**RUIDOSO-RUIDOSO DOWNS REGIONAL WWTP
JOINT USE BOARD**

**PHASE 1A – SLUDGE HANDLING AND
ULTRAVIOLET DISINFECTION
FACILITIES – 2008**

CHANGE ORDER NO. 01

February 11, 2009

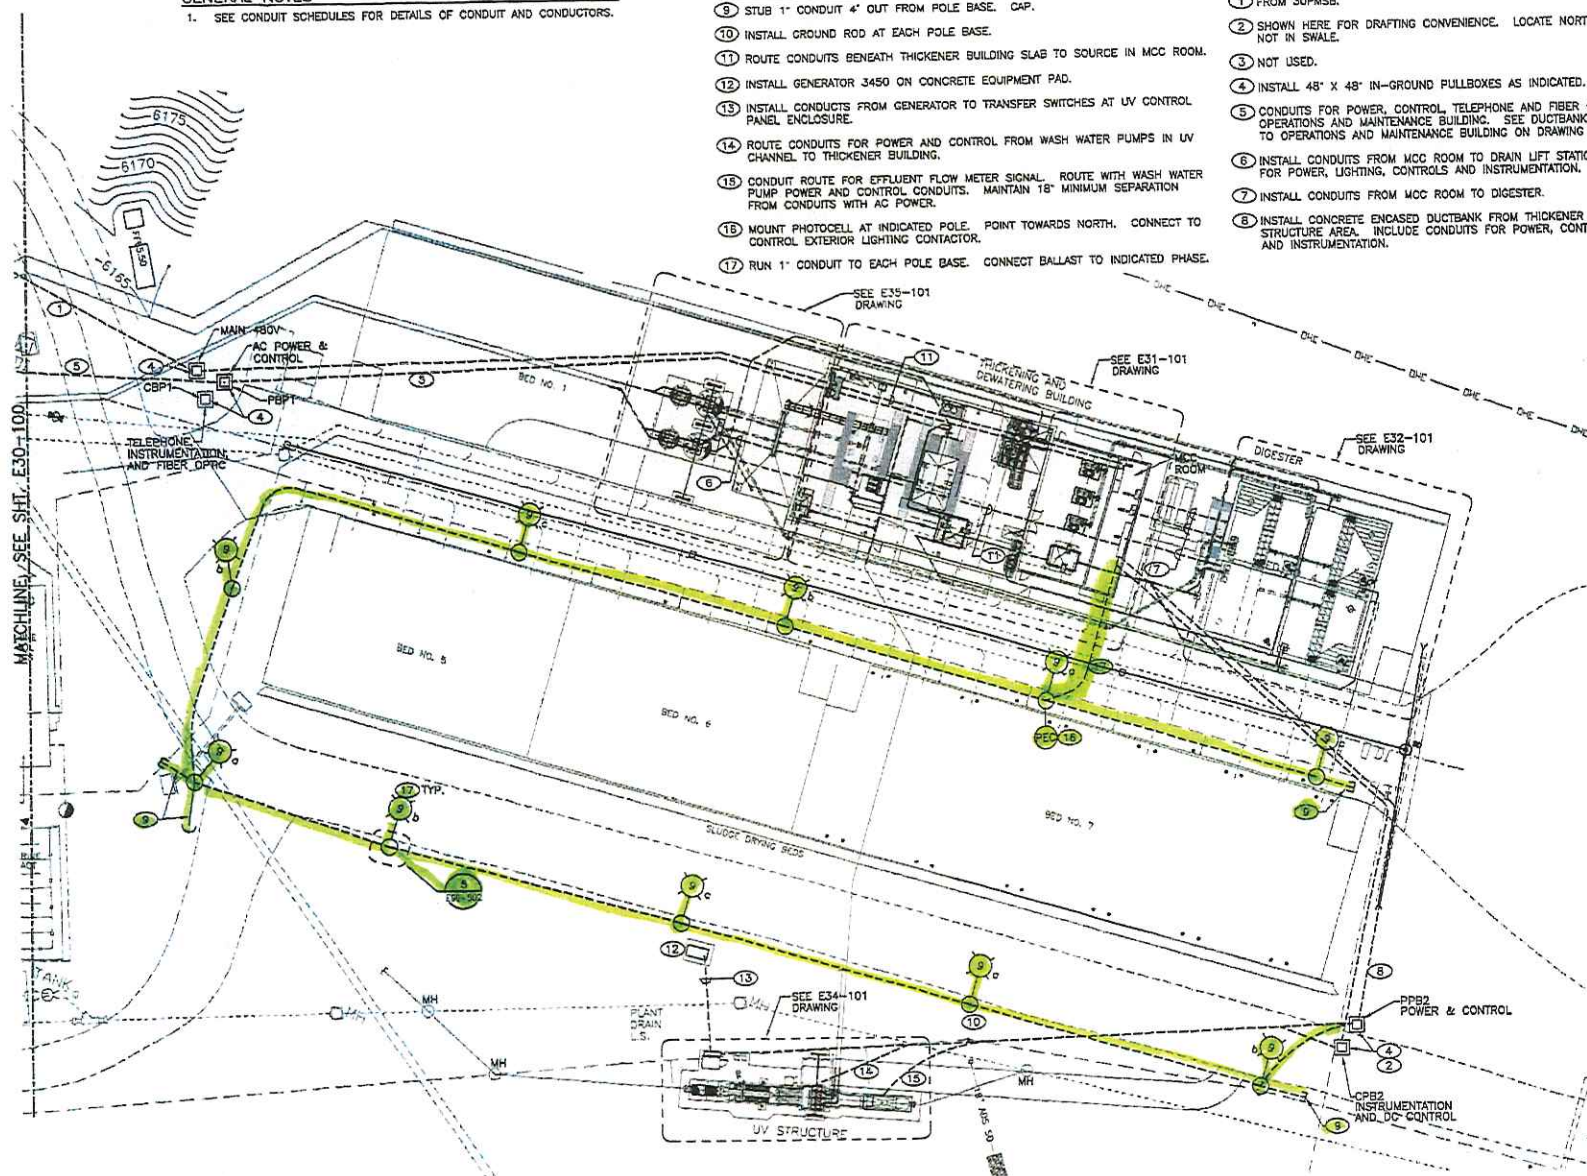
A. SCOPE AND JUSTIFICATION: The Engineer suggested to the Owner to delete the high level of yard lighting and provide minimal task lighting. This concept was accepted by Bill Morris and Cleatus Richards on December 9, 2008 construction meeting. The scope of work for the deleted yard lighting system is shown on the attached Sheet E30-101.

B. ENGINEER'S COMMENTS: The Contractor's price proposal is for a credit of -\$34,007.74 for deletion of 10 light poles and support systems shown on drawing Sheet E30-101 (attached). No

W30-101
PAGE 11

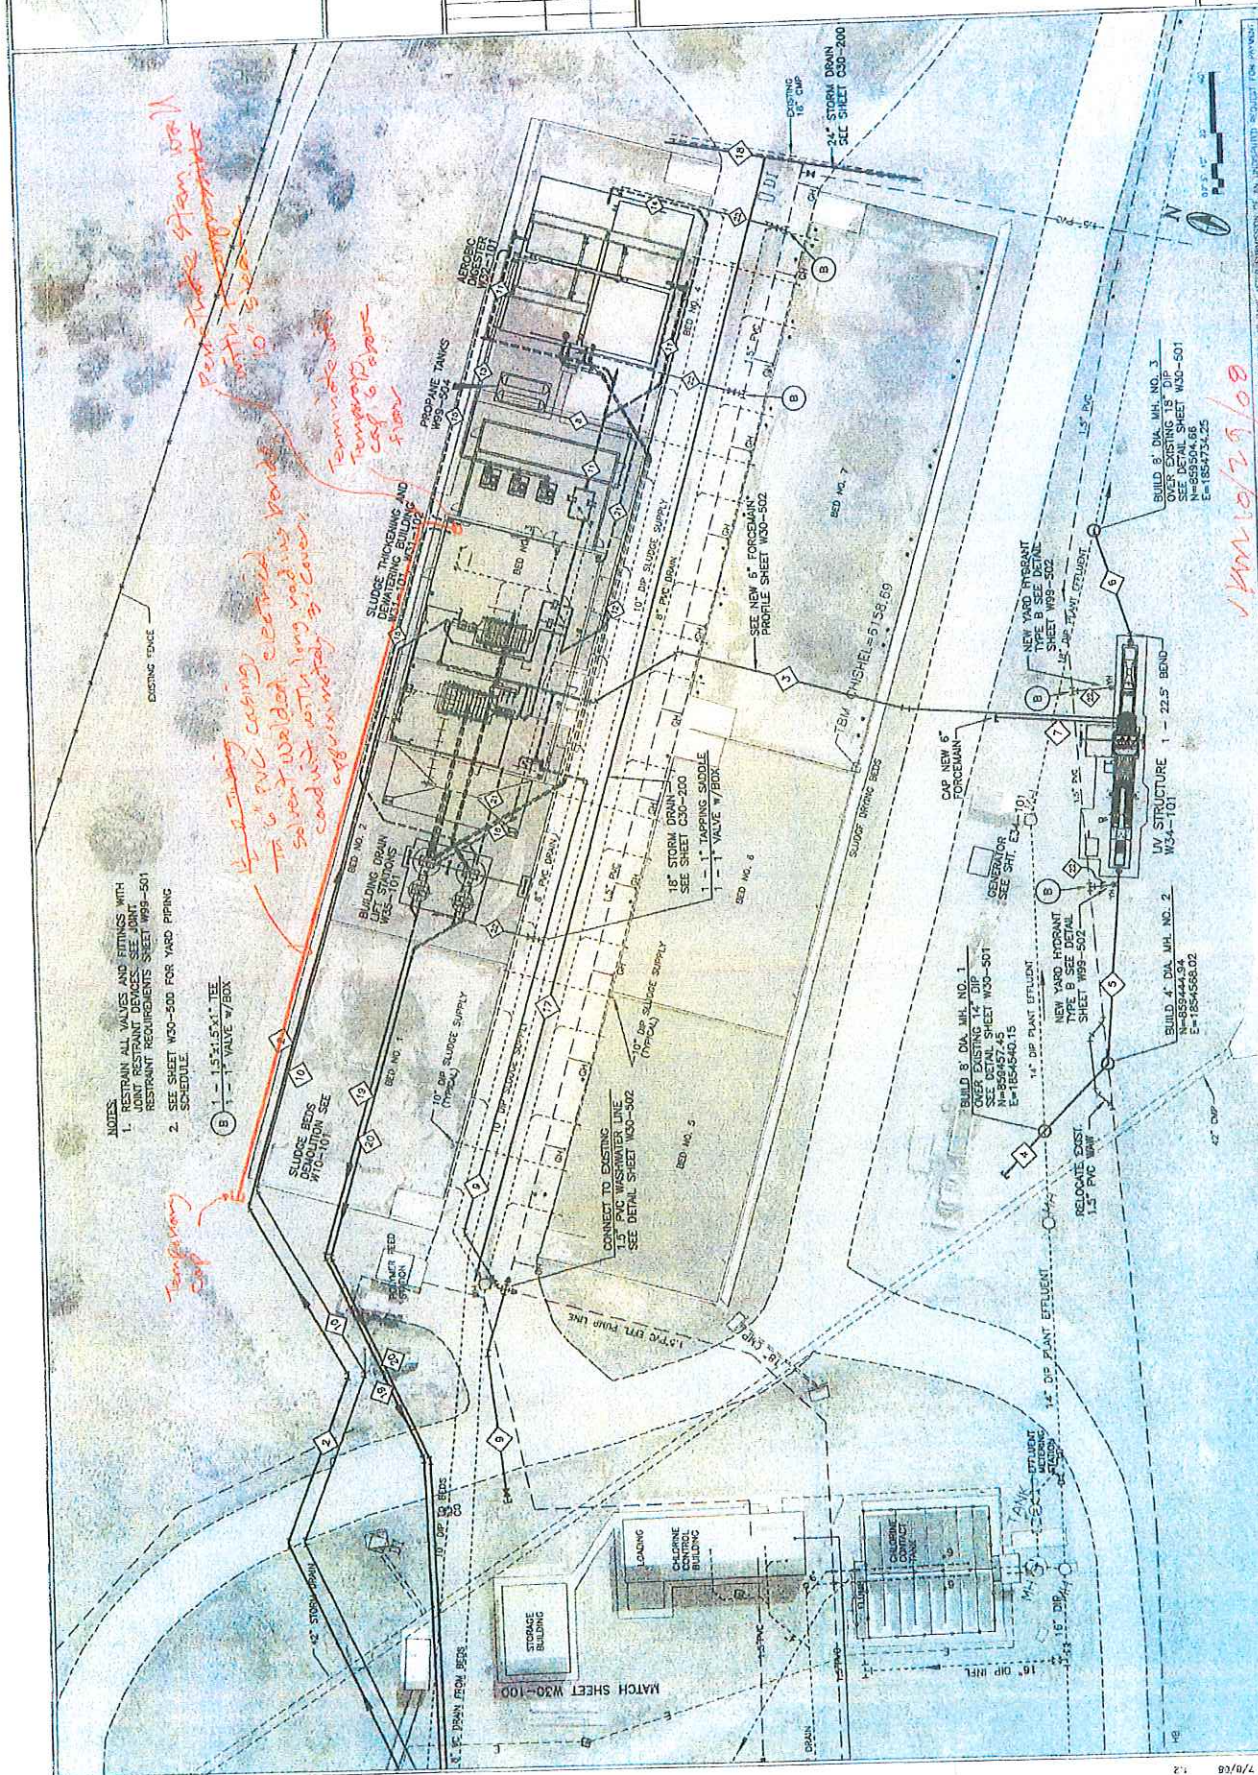
A. SCOPE AND JUSTIFICATION: Per email dated October 30, 2008 requesting to change swing type check valves (Sheet W31-305, Keyed Note 7) to Ball Check Valves, HDL type, flange ends.

Description: Sheet W31-305 Keyed Note 7 changed to "Ball Check Valve (HDL type), flanged end" on sludge lines (5 places).

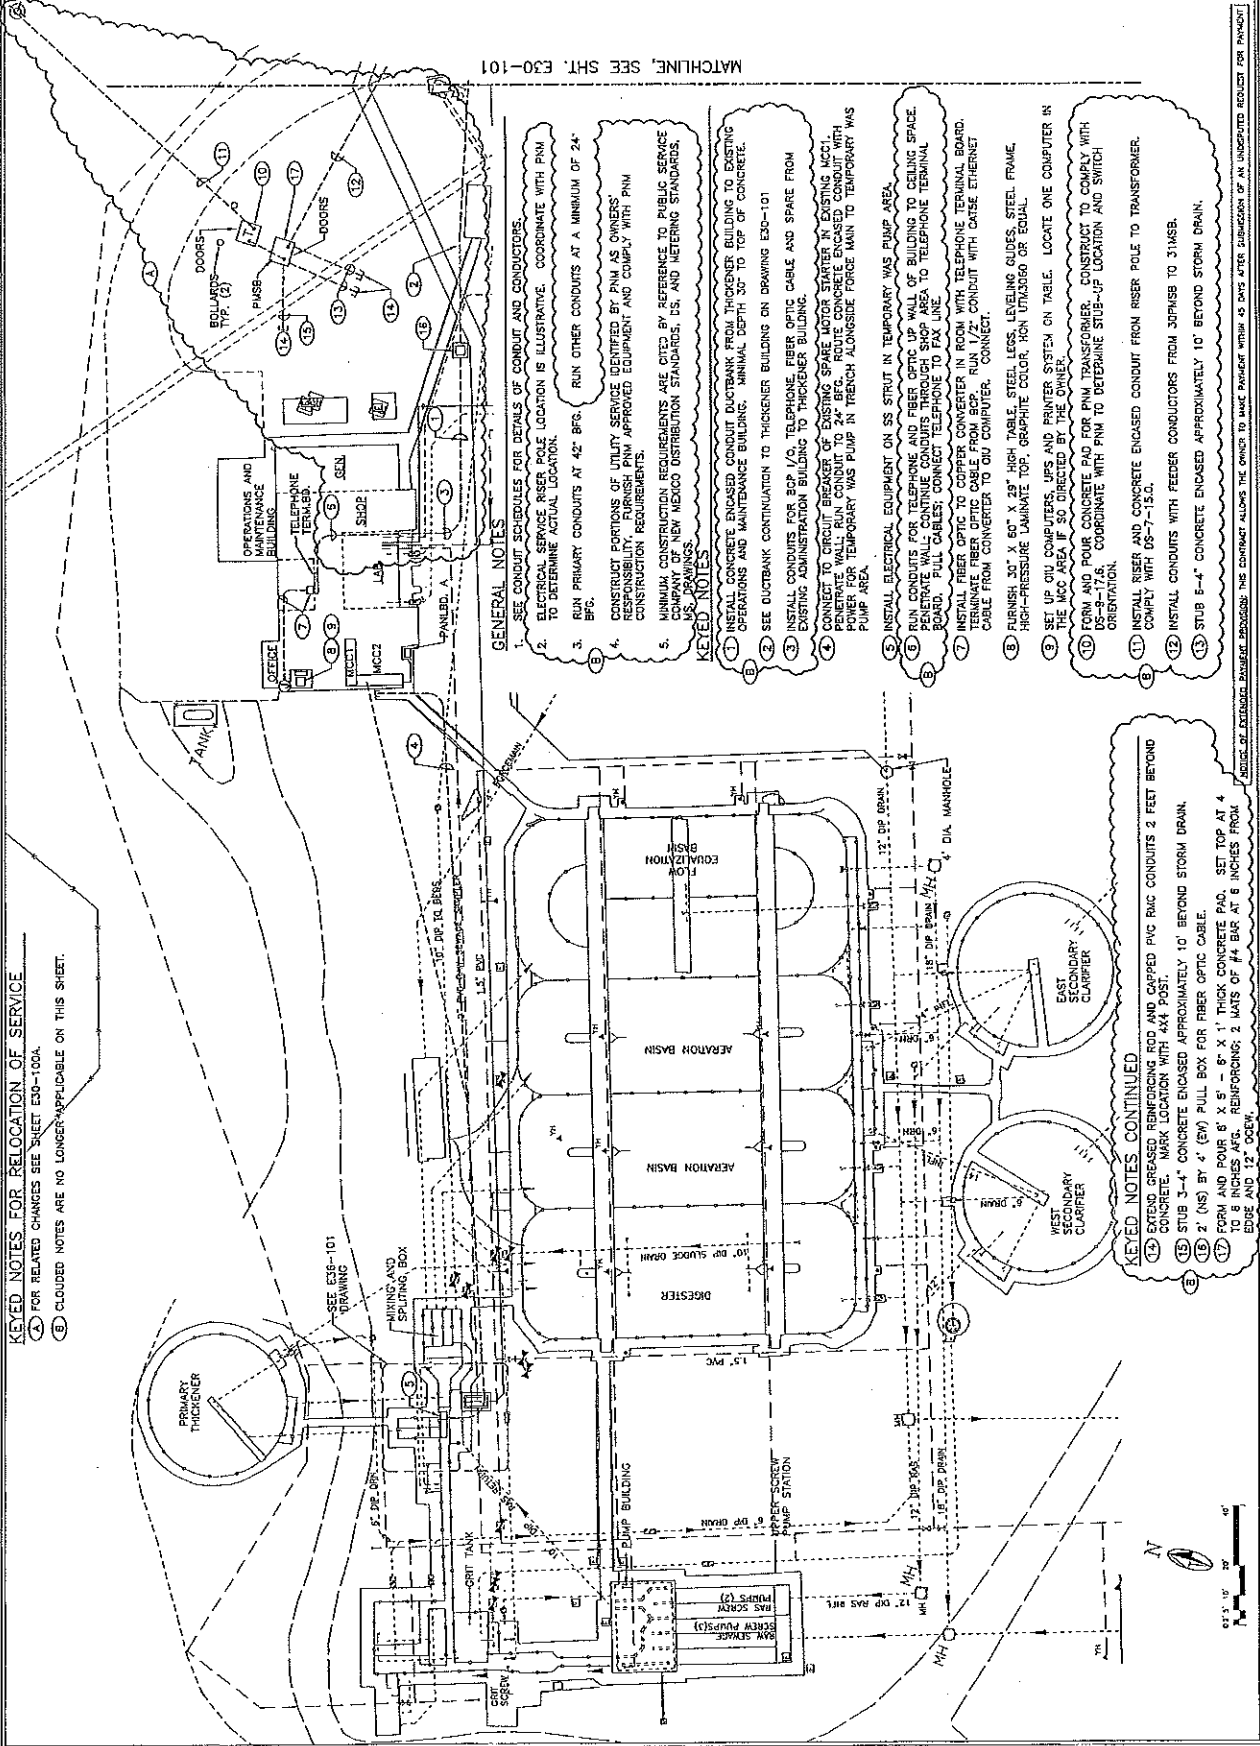
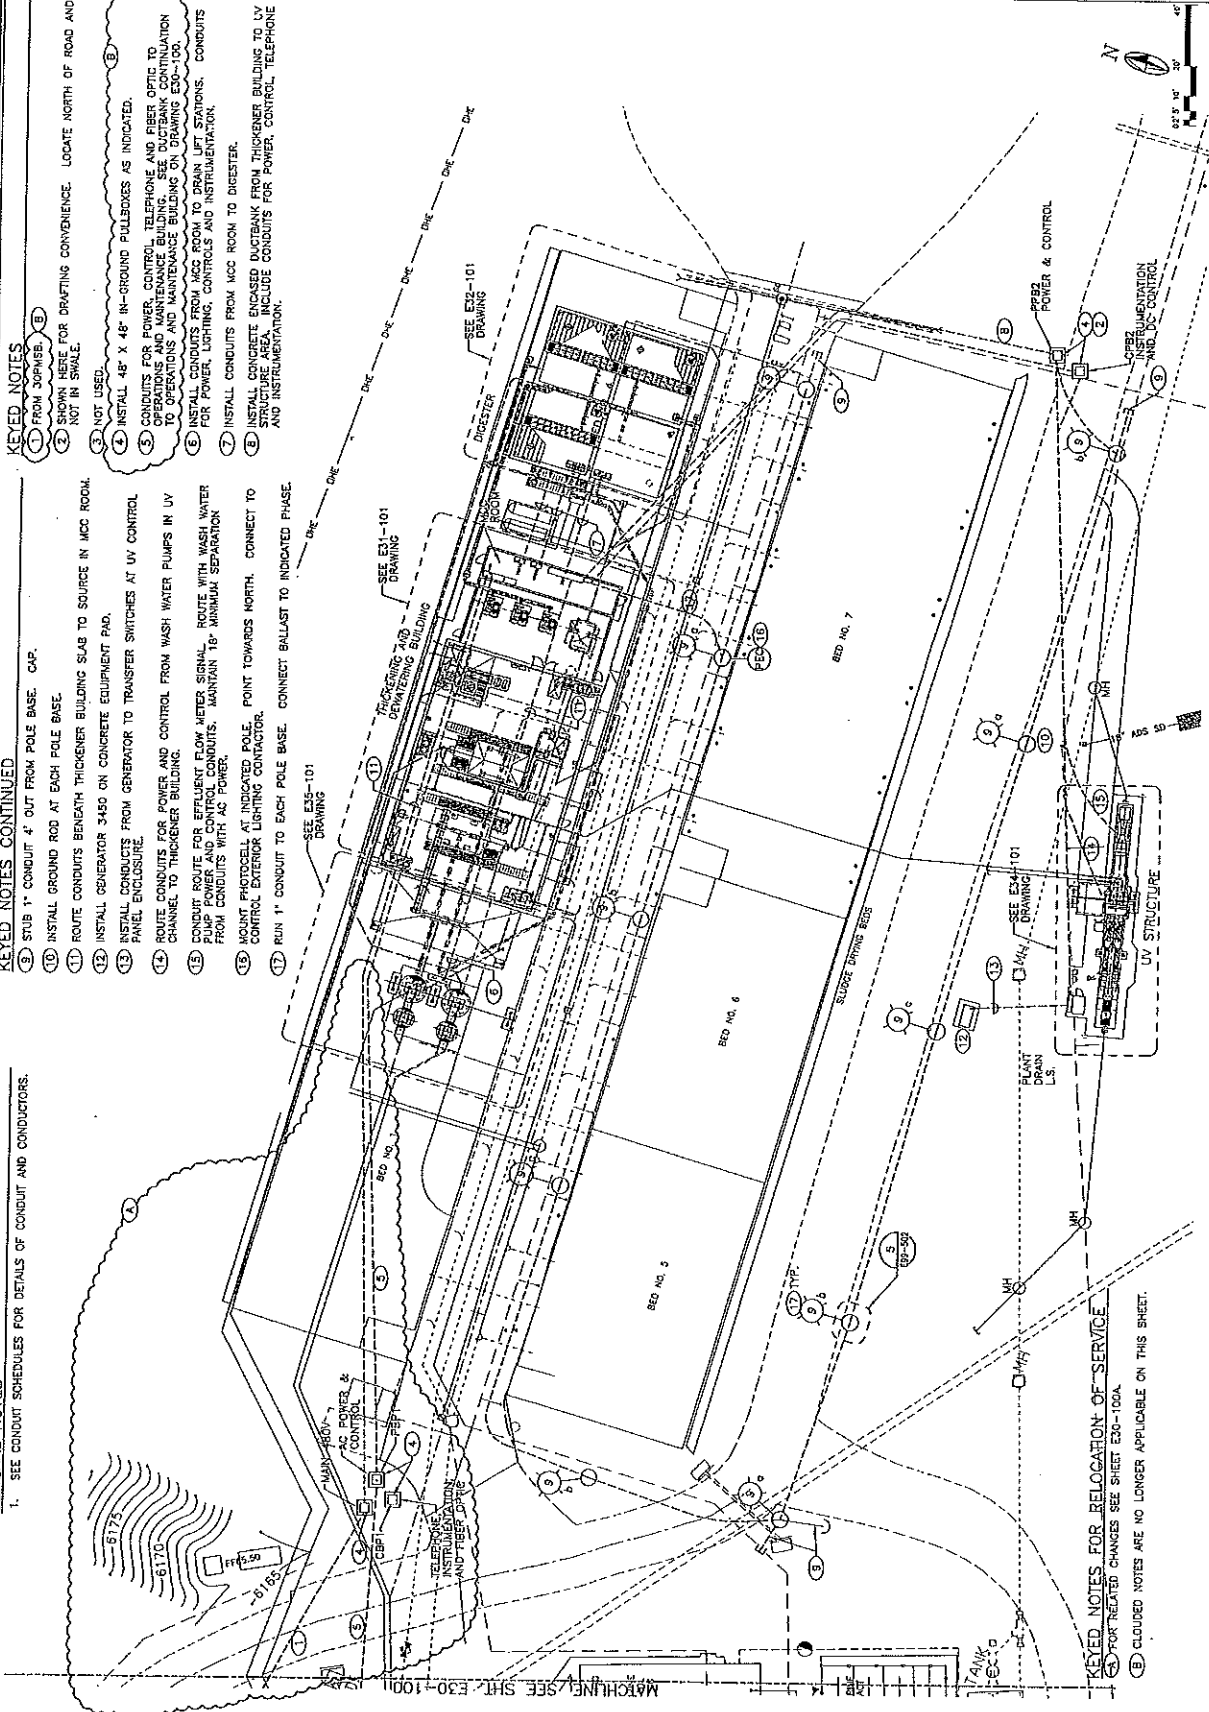
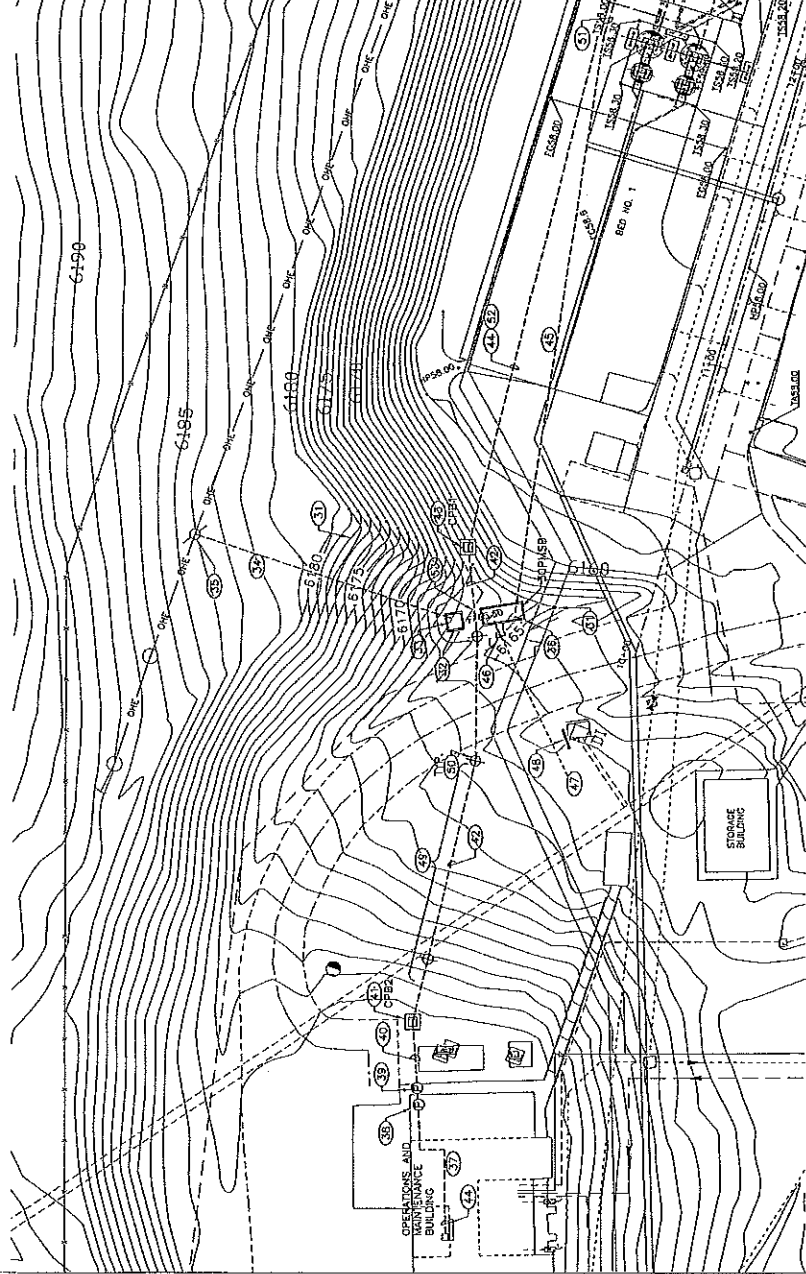
1. During the design of Phase 1A, a new primary service and new plant main switchboard, 30PMSB was shown. Knowing that Phase 1B would follow closely, it was sized for Phase 1A loads and a portion of Phase 1B loads and the switchboard was located east of the existing Administration Building, the location being chosen as convenient for both purposes.
2. During the design of Phase 1B, the decision was made to fill the area east of the existing Administration Building in order to provide parking and ADA access to the office and lab area in the new structure. Therefore, the new service will need to be moved. There are also some control conduits which are affected.

1. Move the new utility transformer and the switchboard toward the northeast, moving associated power conduits to match. This will require some changes to the grading.
2. Move control conduit runs and associated boxes northward.

1. Sheets E30-100R1 and E30-101R1 show the equipment and conduits in locations as bid and show modifications to remove all affected items from these sheets. A side effect of the relocation will be deletion of two in-ground pullboxes, at least one of which will be added to the Phase 1B design. The lengths of several conduits will change, again with some effect on Phase 1B. The amount of work performed by Otero County Electric Cooperative will be slightly less.
2. Because there is a match line in the original design, a new sheet, E30-100A, was created in order to show the relocated equipment and conduits on a single sheet. This sheet shows
 - a. New contours, requiring additional grading.
 - b. New location of the primary riser pole, primary conduit, utility transformer, switchboard 30PMSB, and affected power conduits.
 - c. New location of control conduits and boxes.

- (A) FOR RELATED CHANGES SEE SHEET E30-100A
- (B) CLOUDED NOTES ARE NO LONGER APPLICABLE ON THIS SHEET.
